Does 1166L
BNSF Need Plans?
~~Hal Industrial~~ Barnett Industrial
BNSF Conflict Sta 16620+00 WL

~~SECRET~~
BNSF Conflict No. 27 & 28

BNSF Conflict No. 36

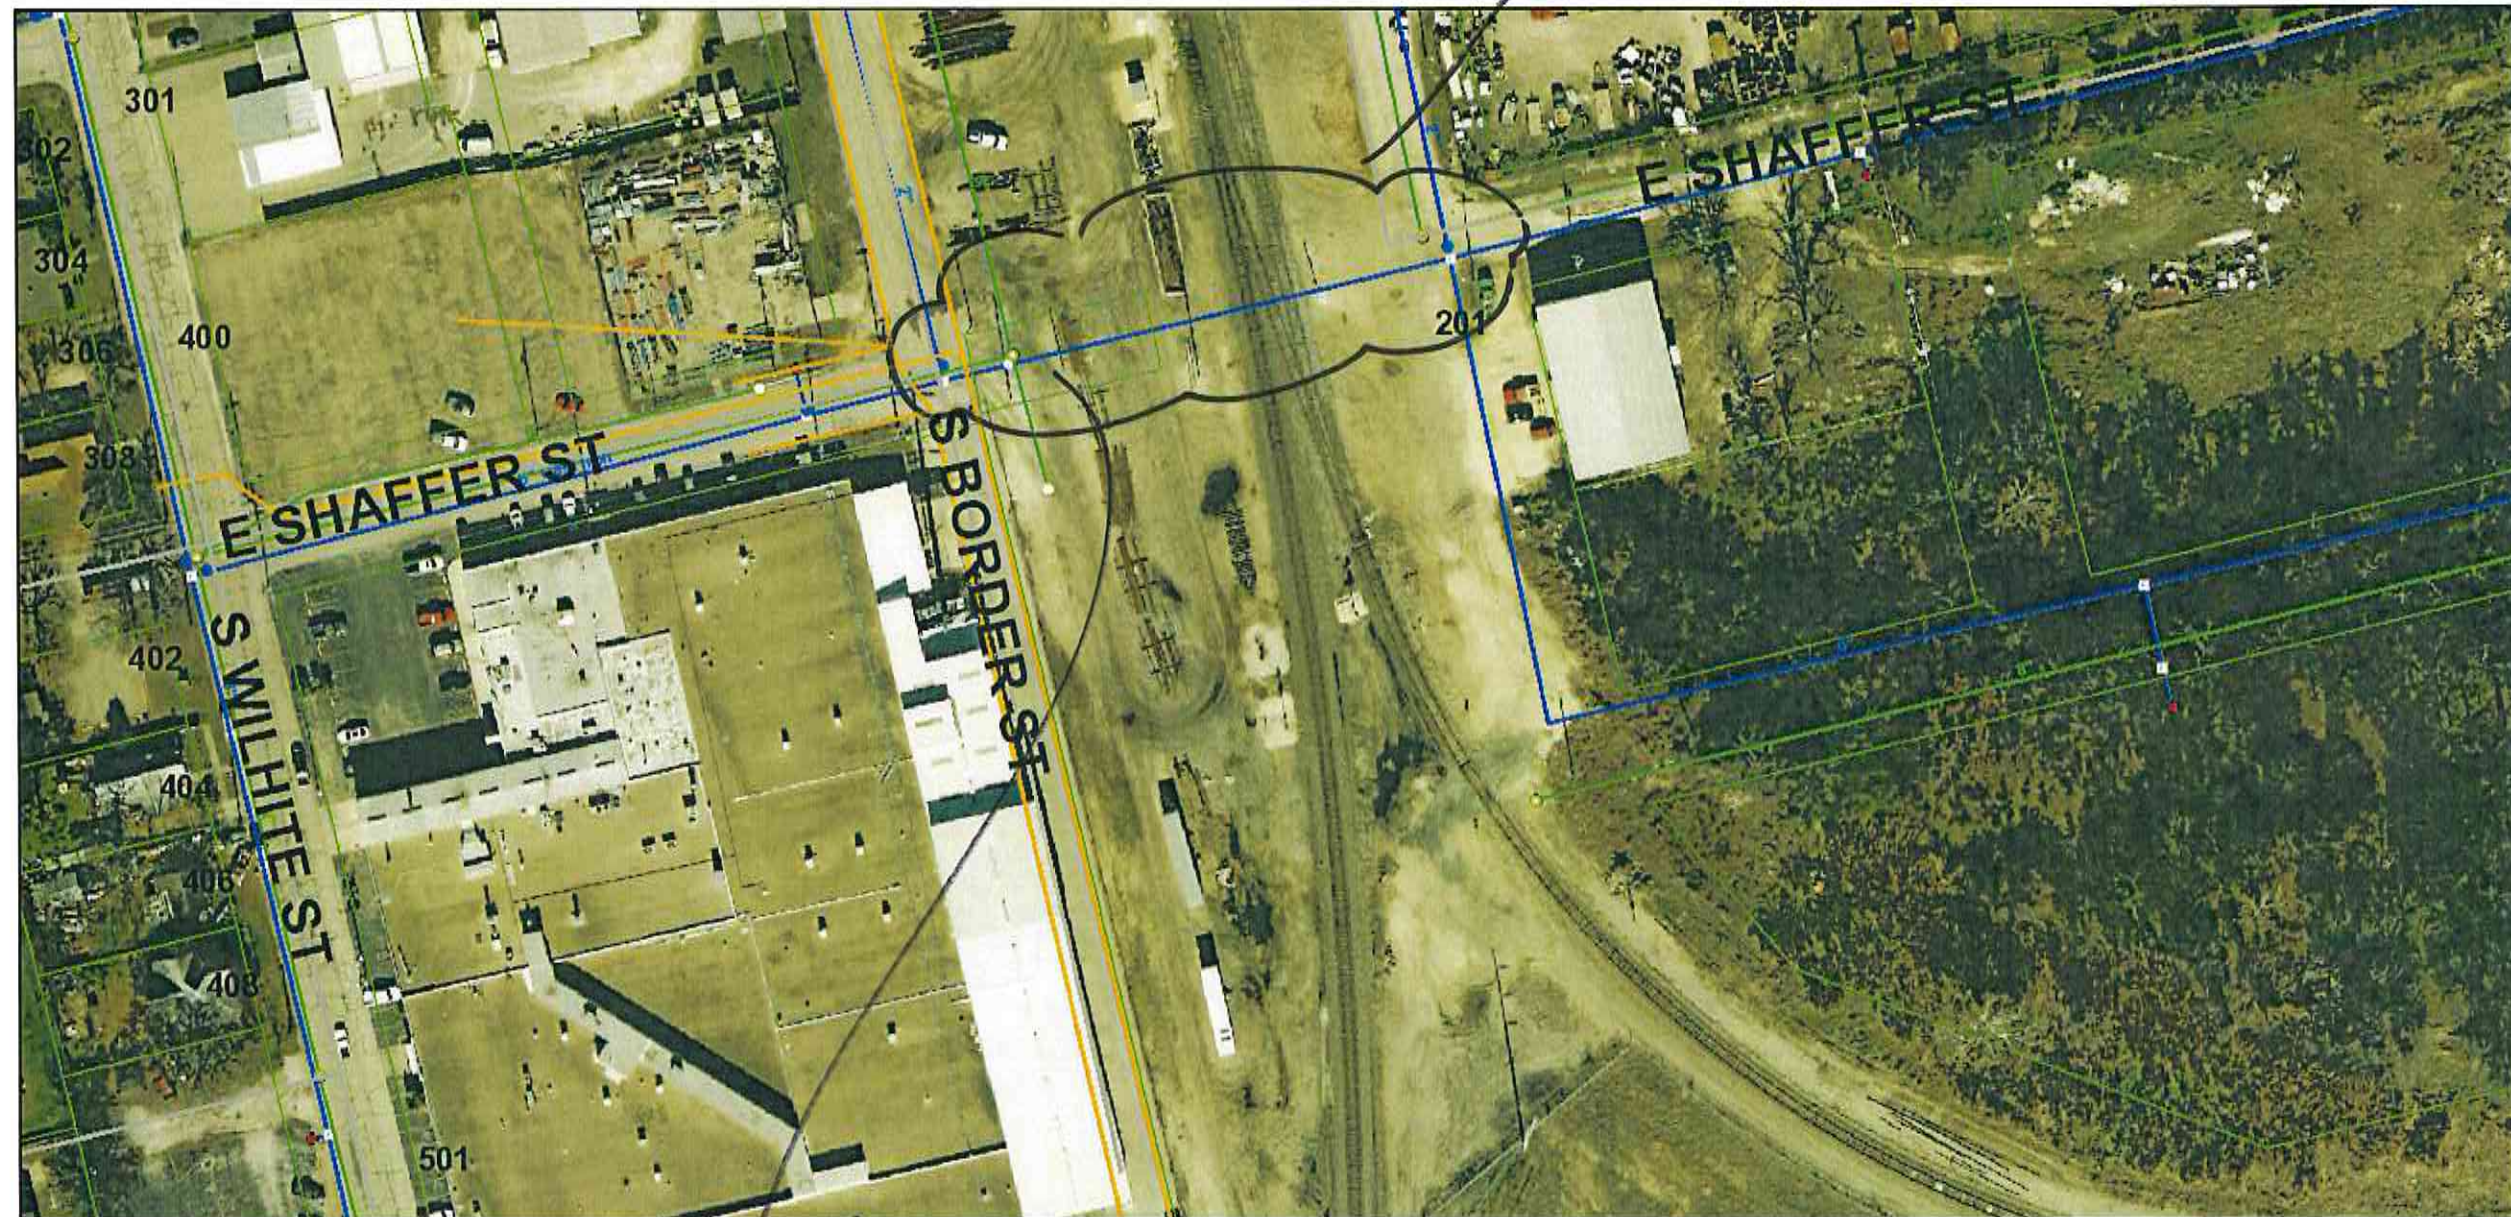
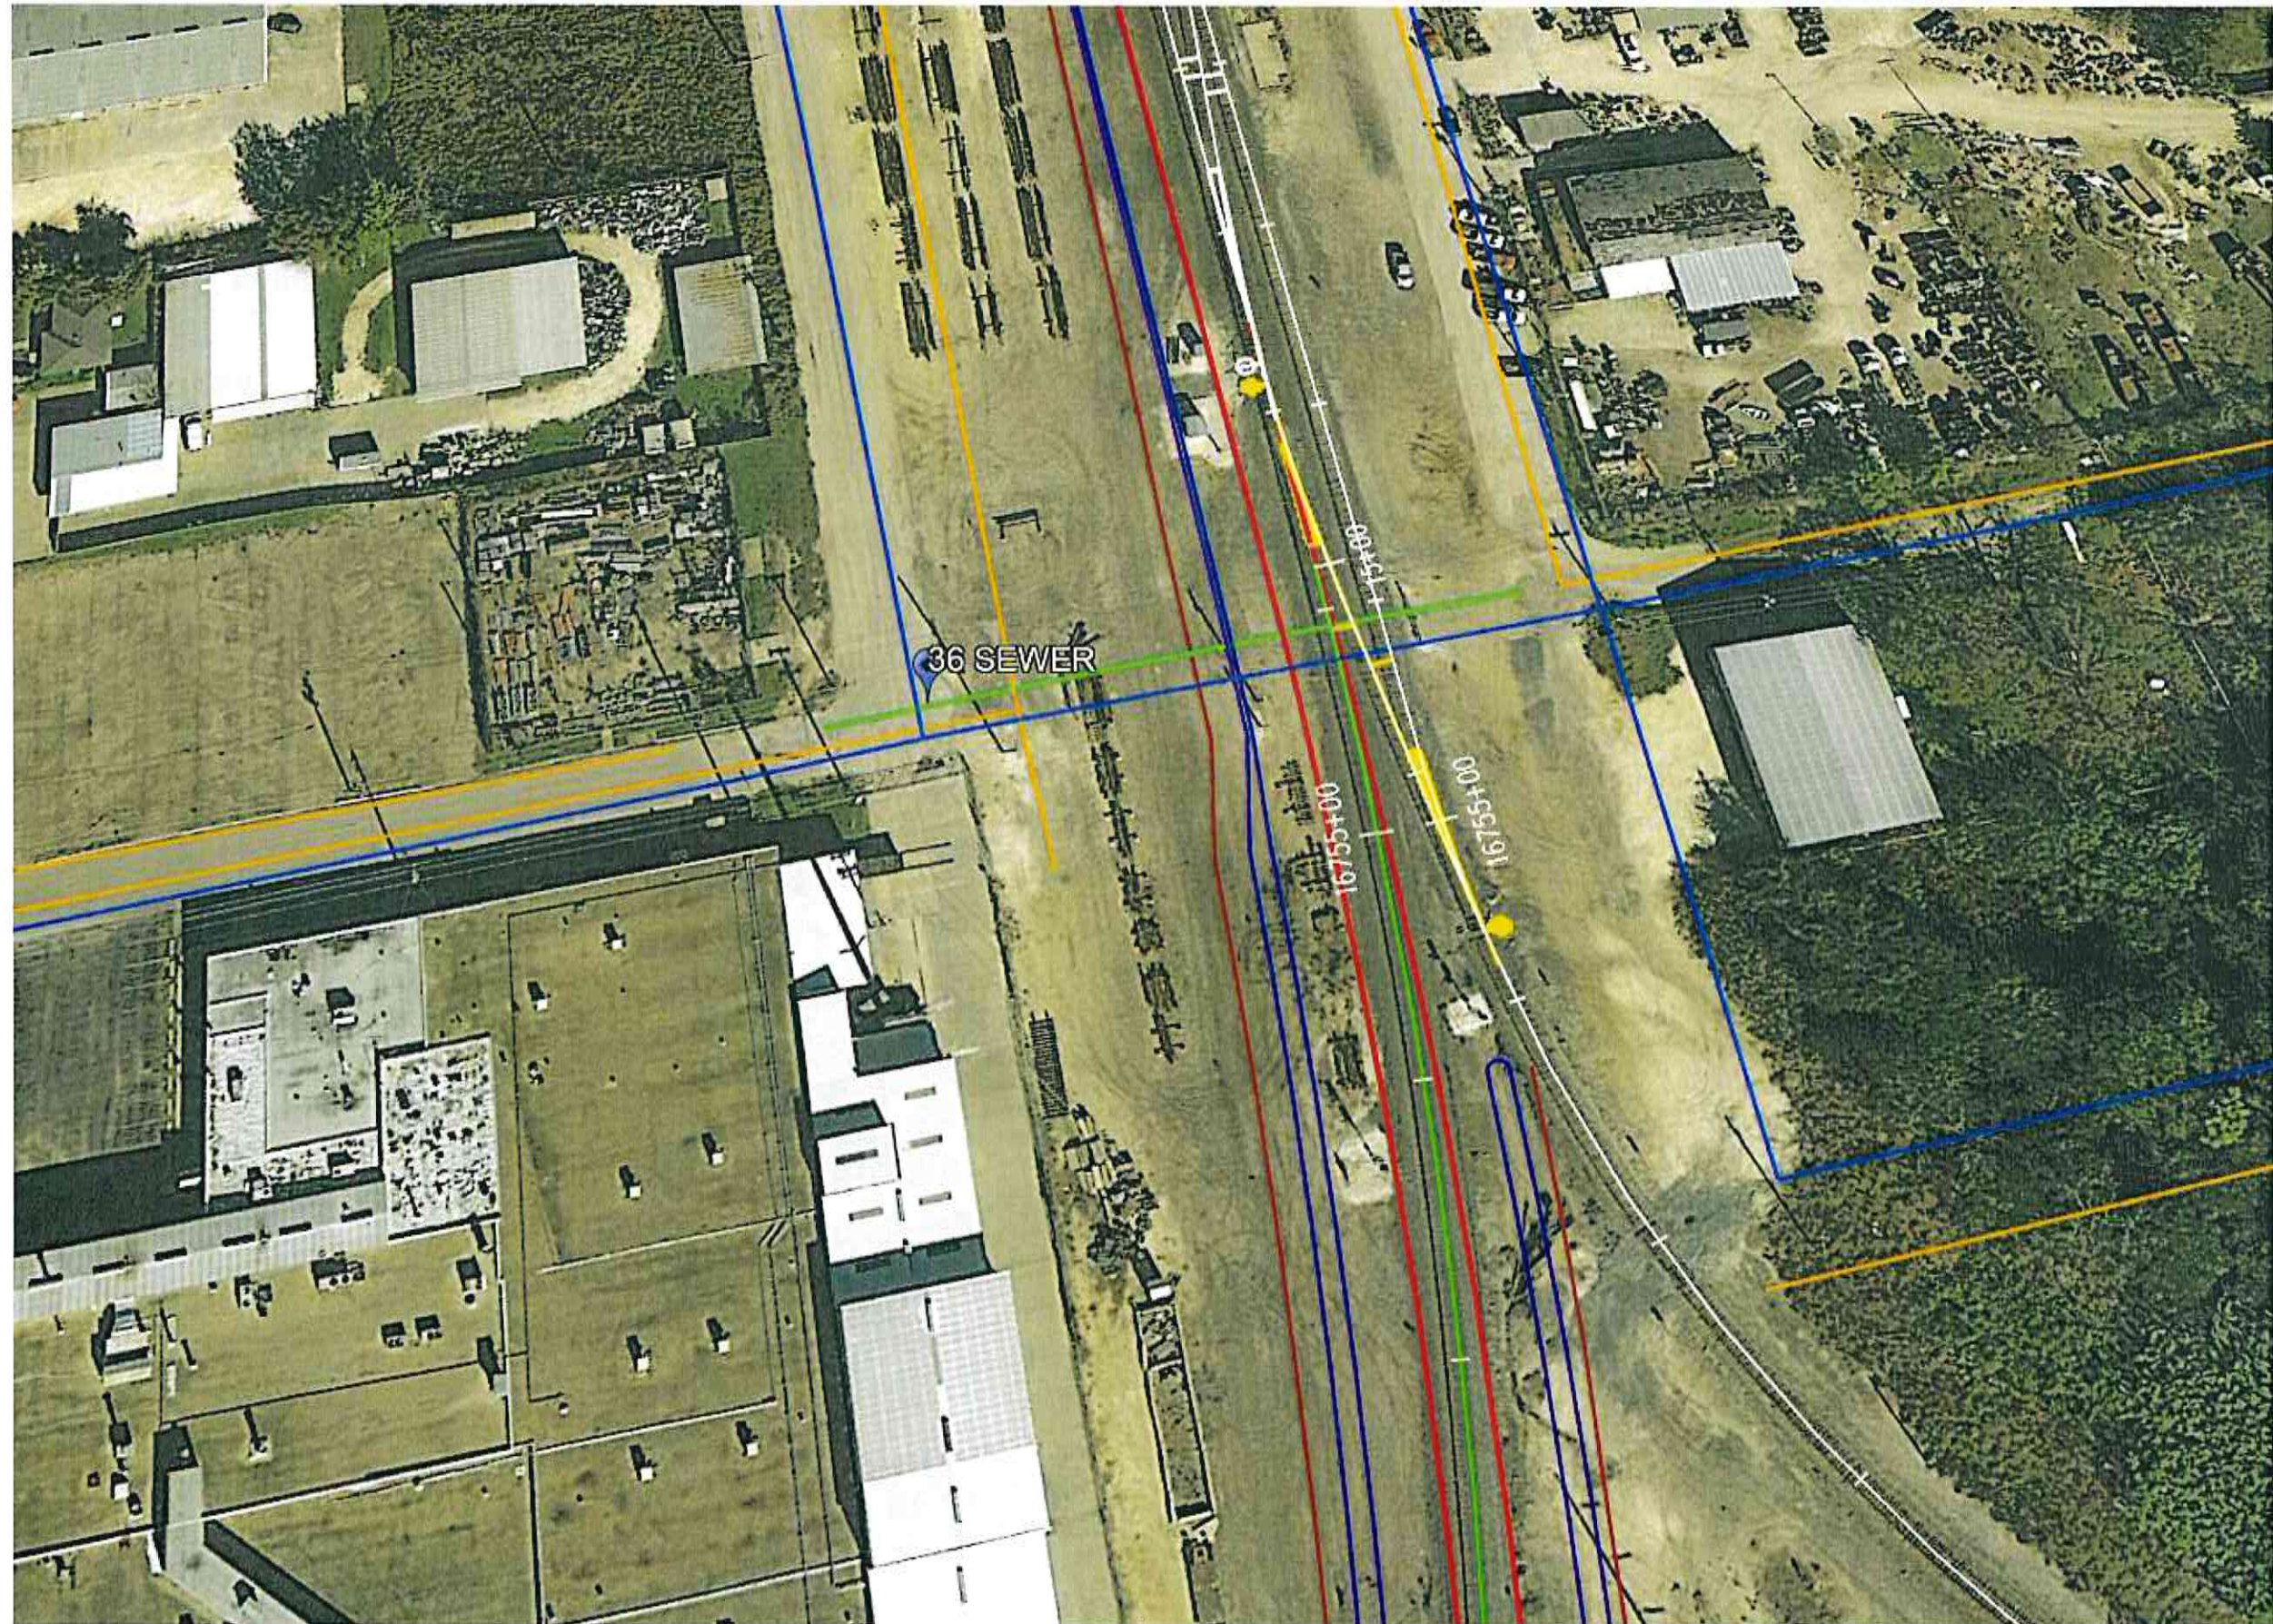
no sewer existing

no information on file for this water line

- not shown on city's GIS - no sewer at this location
- not concerned with water line?
